Consented VS Proposed

DESIGN SUMMARY

Stephenson's Way

Planning Permission Nr.: 2018/2316/P

Consented vs Proposed - First Floor

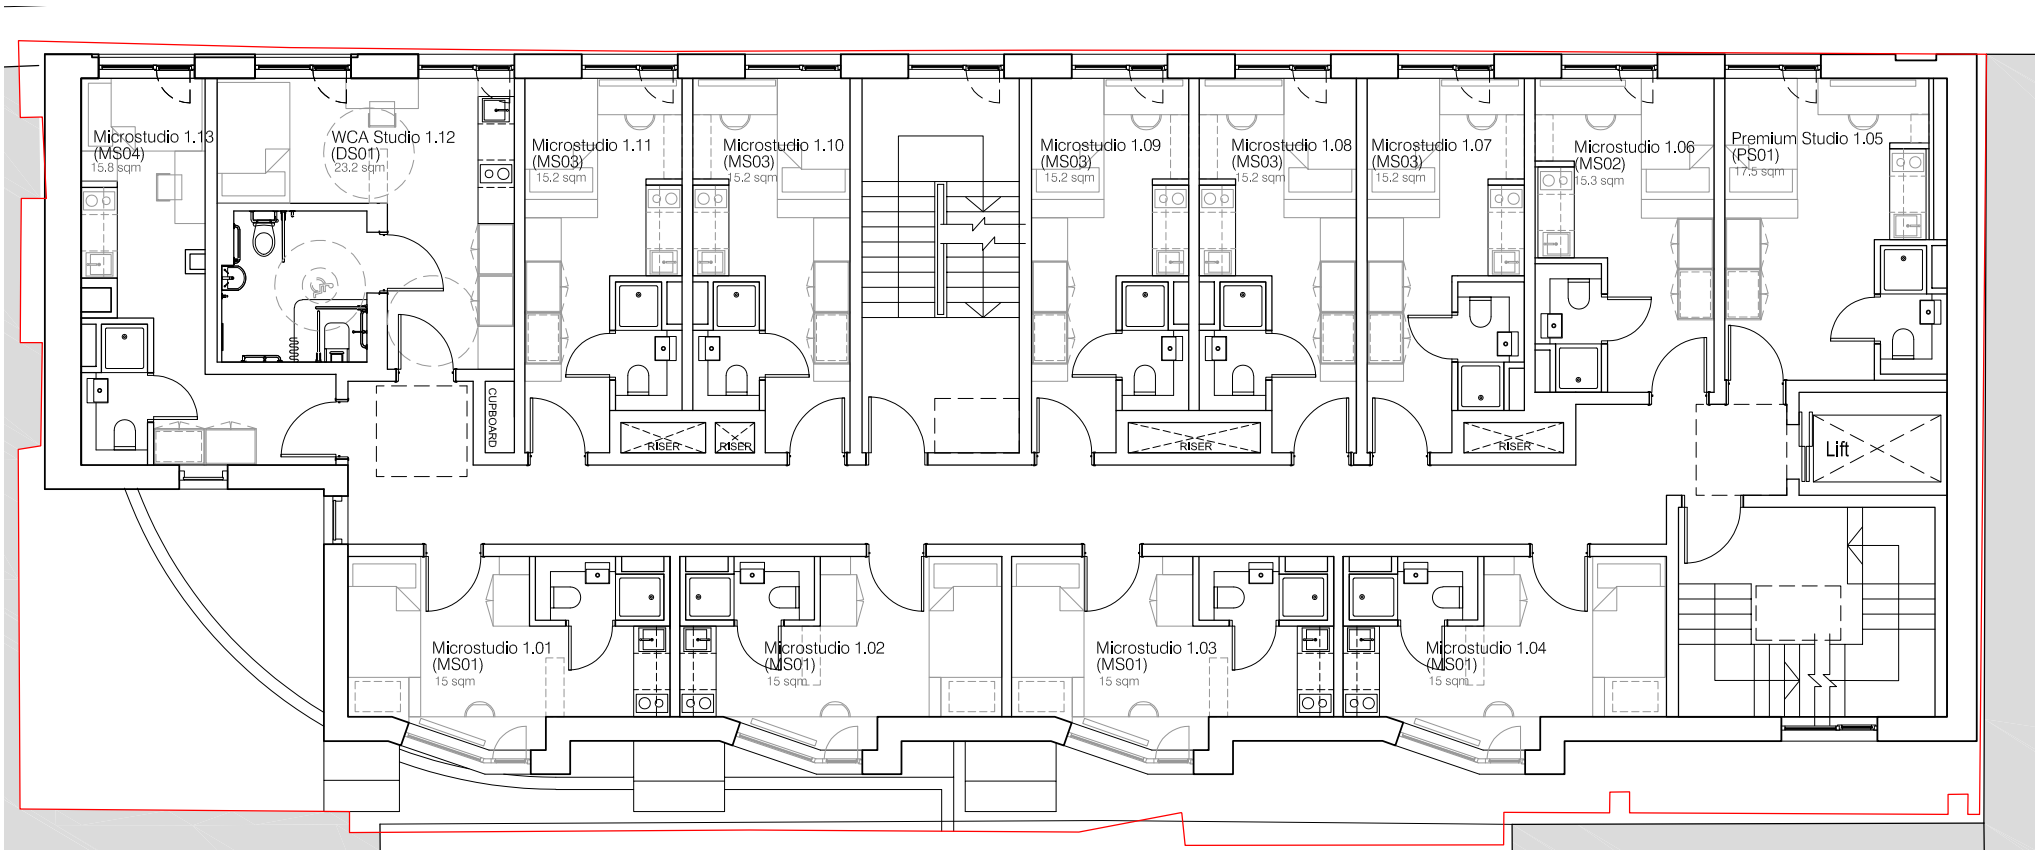
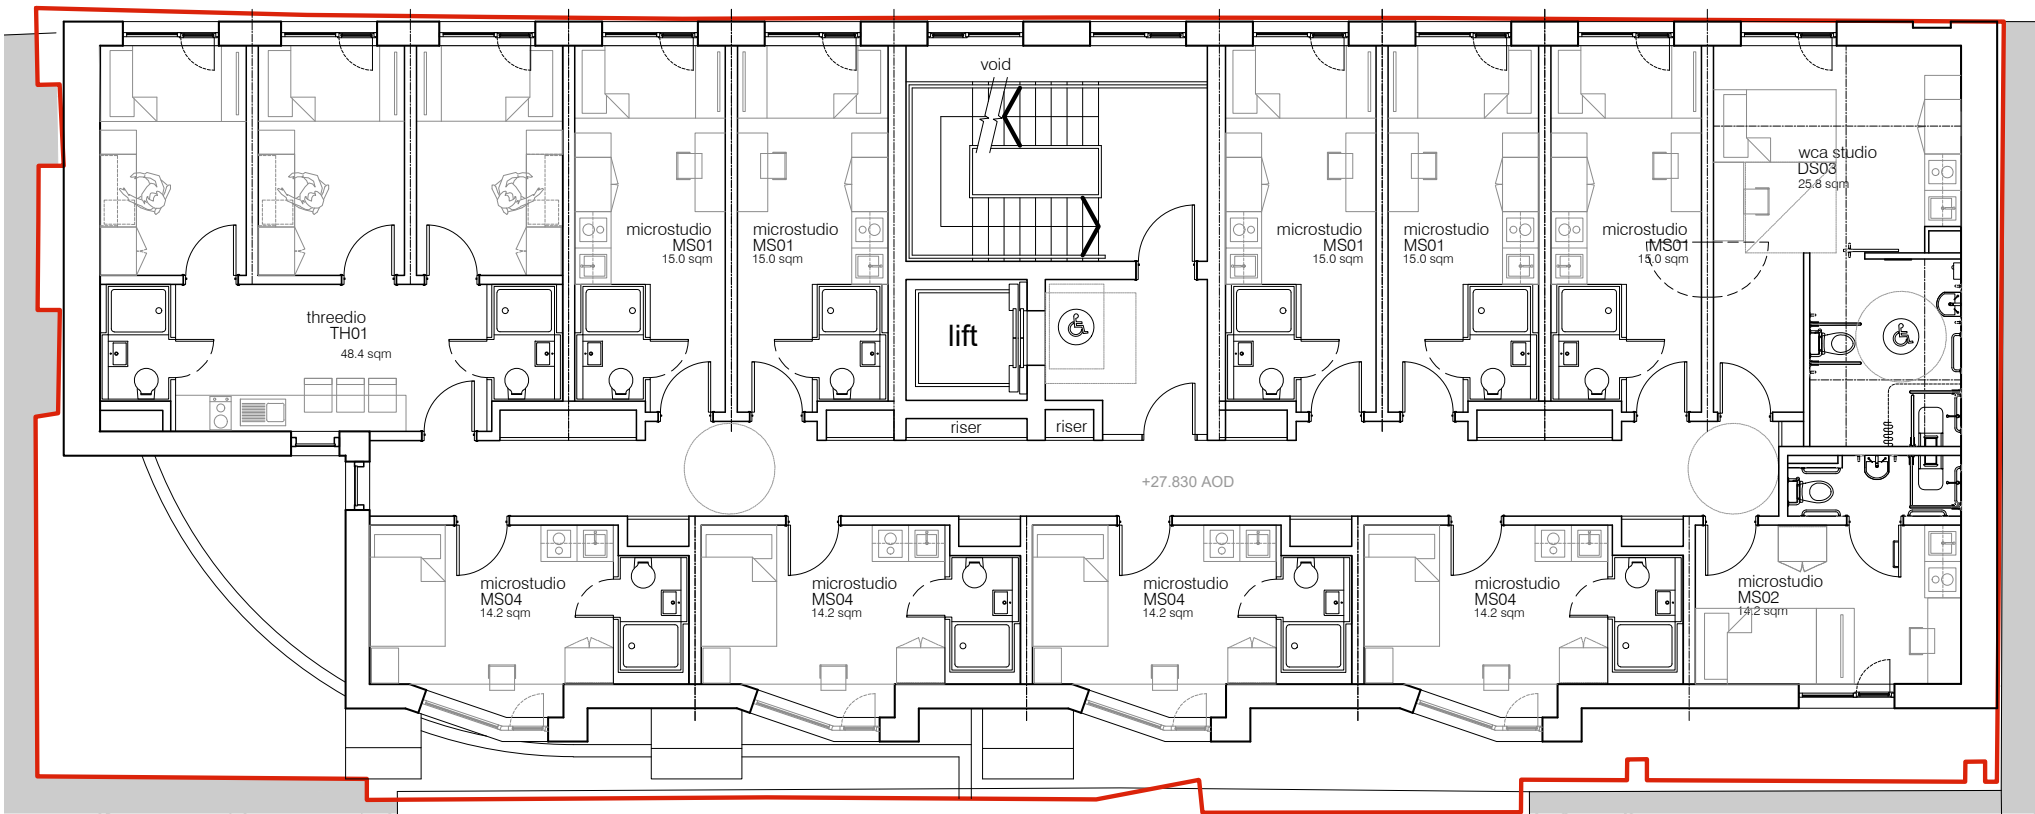
- 1. Secondary stair core added to comply with building safety act and revised building regulations.
- 2. Increased plant areas and UKPN substation added to comply with revised building regulations and increased services requirements.
- 3. Reduction in numbers of studios from 78 to 72 rooms due to secondary stair core and removal of threedio's on the recommendations of the fire consultant as a result of revised building regulations, but still maintaining minimum room sizes required.
- 4. Relocation of platform lift to rear façade to allow for access to the bin store due to new stair location.
- 5. Minor correction to existing ground floor levels due to inaccurate original survey.
- 6. Minor amendments to floor levels due to detailed structural design.

Consented vs Proposed - Second Floor

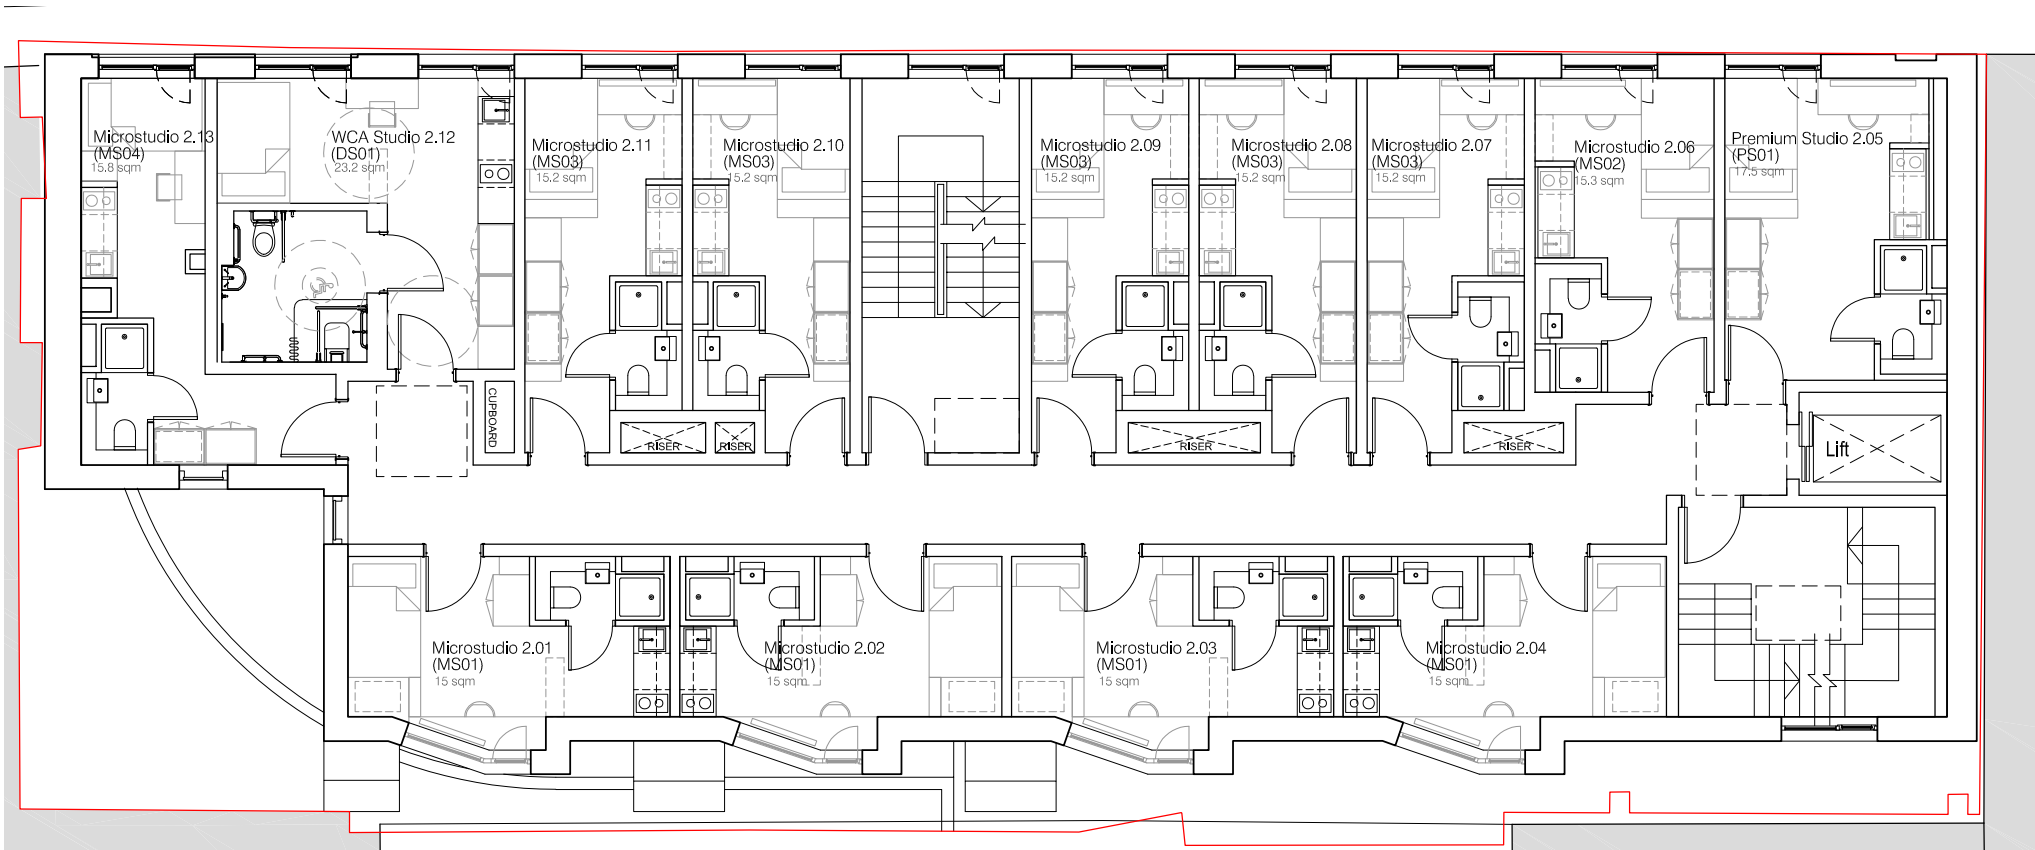
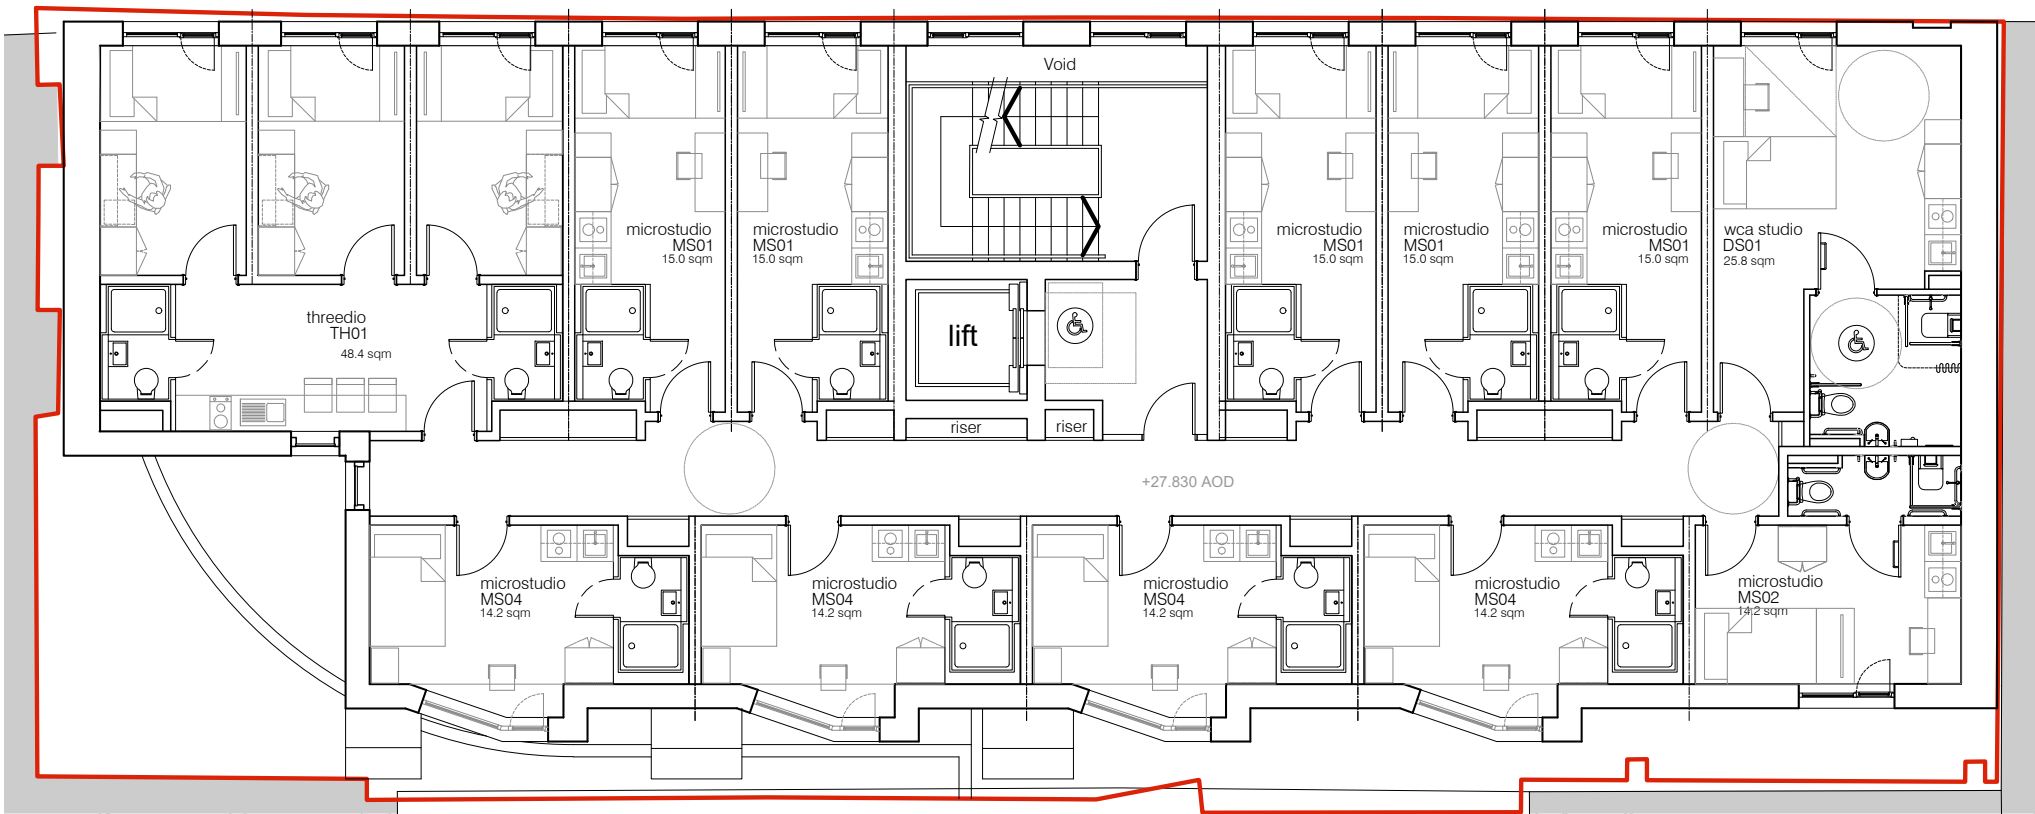
- 1. Secondary stair core added to comply with building safety act and revised building regulations.
- 2. Increased plant areas and UKPN substation added to comply with revised building regulations and increased services requirements.
- 3. Reduction in numbers of studios from 78 to 72 rooms due to secondary stair core and removal of threedio's on the recommendations of the fire consultant as a result of revised building regulations, but still maintaining minimum room sizes required.
- 4. Relocation of platform lift to rear façade to allow for access to the bin store due to new stair location.
- 5. Minor correction to existing ground floor levels due to inaccurate original survey.
- 6. Minor amendments to floor levels due to detailed structural design.

Consented vs Proposed - Third Floor

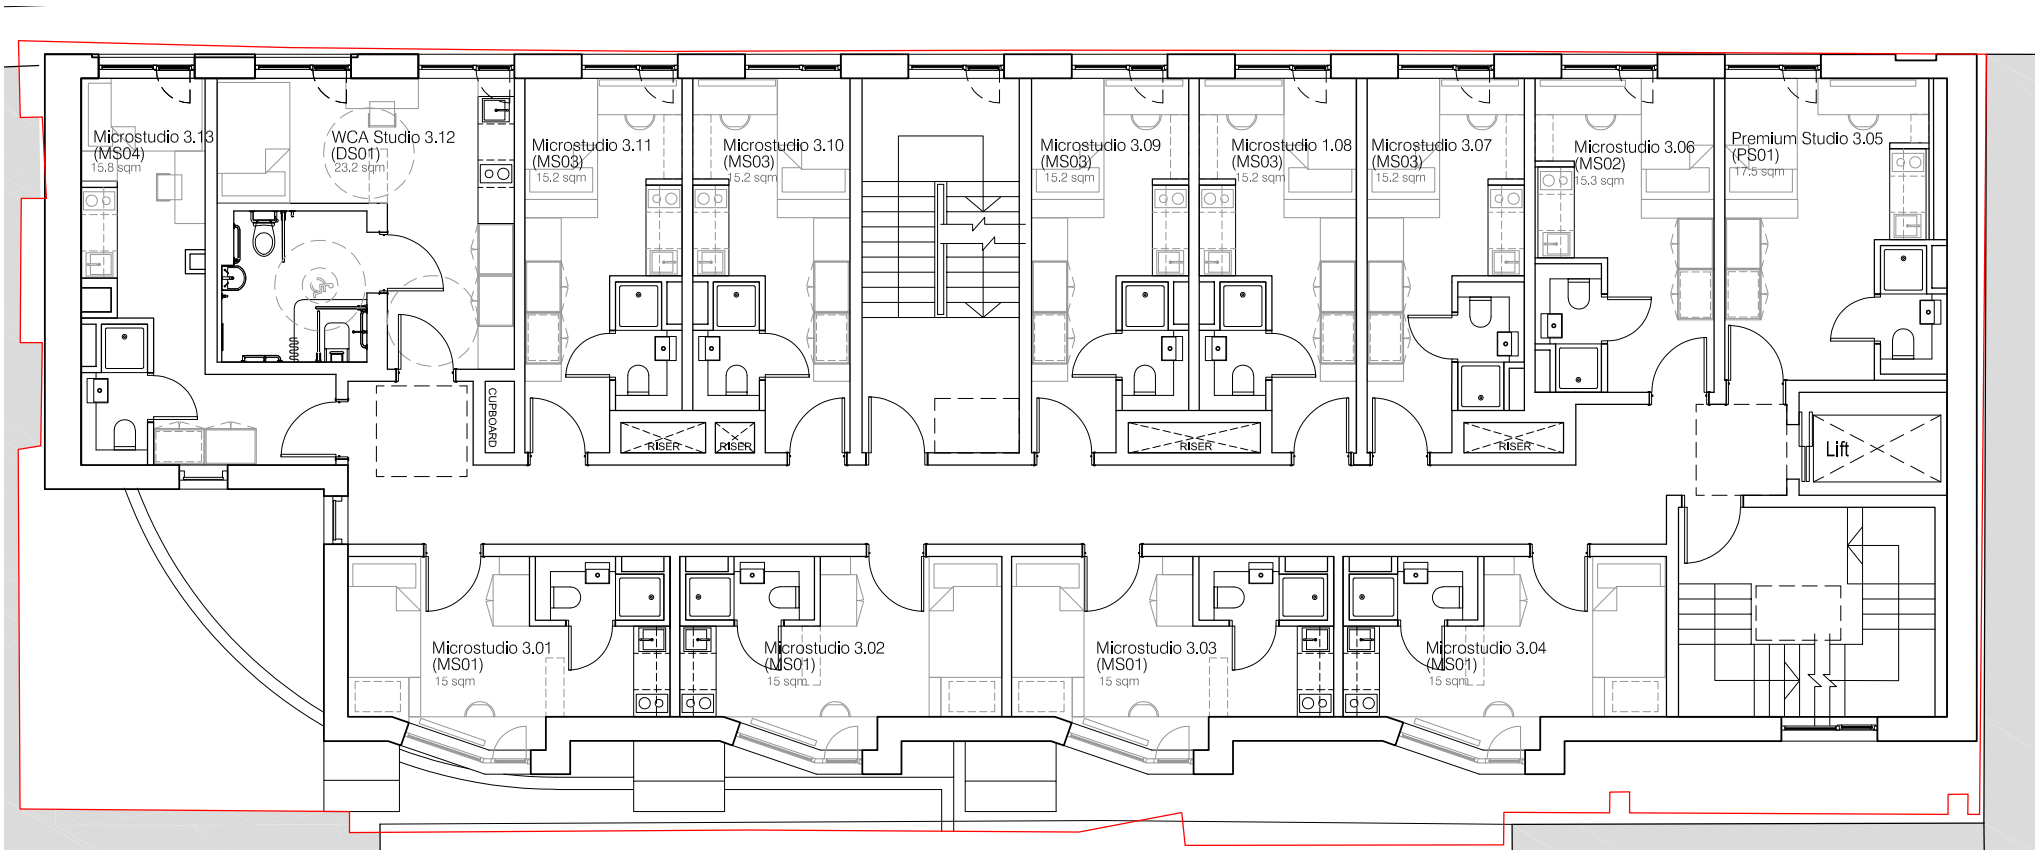
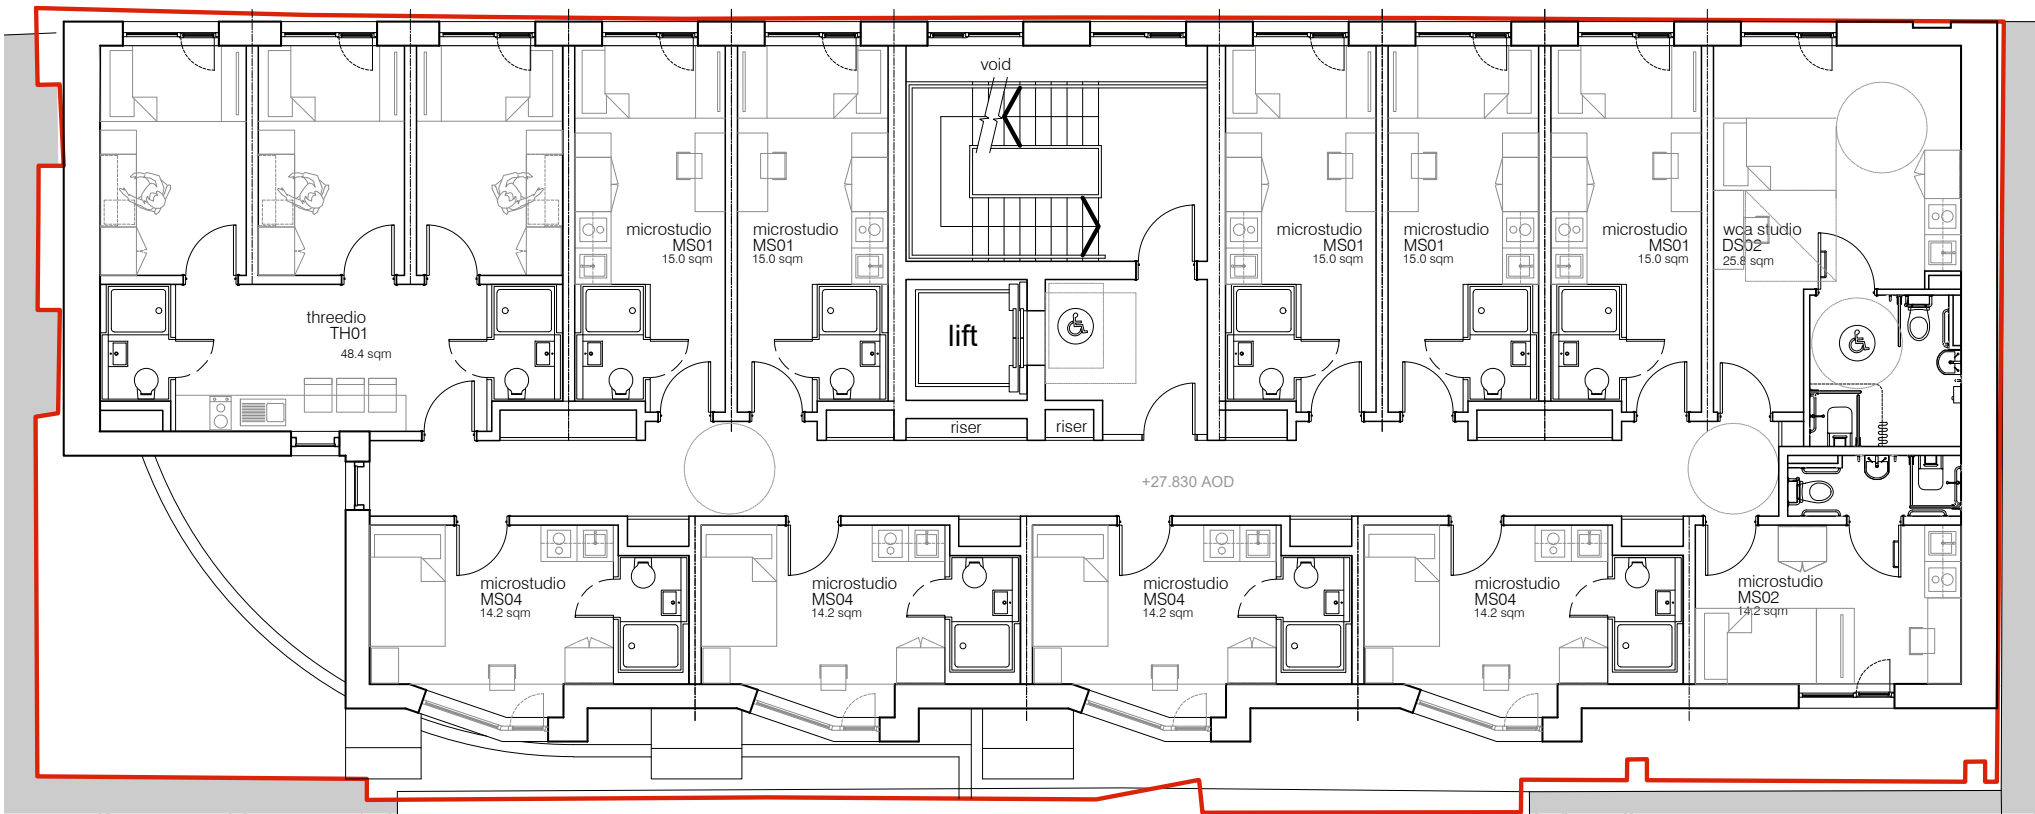
- 1. Secondary stair core added to comply with building safety act and revised building regulations.
- 2. Increased plant areas and UKPN substation added to comply with revised building regulations and increased services requirements.
- 3. Reduction in numbers of studios from 78 to 72 rooms due to secondary stair core and removal of threedio's on the recommendations of the fire consultant as a result of revised building regulations, but still maintaining minimum room sizes required.
- 4. Relocation of platform lift to rear façade to allow for access to the bin store due to new stair location.
- 5. Minor correction to existing ground floor levels due to inaccurate original survey.
- 6. Minor amendments to floor levels due to detailed structural design.
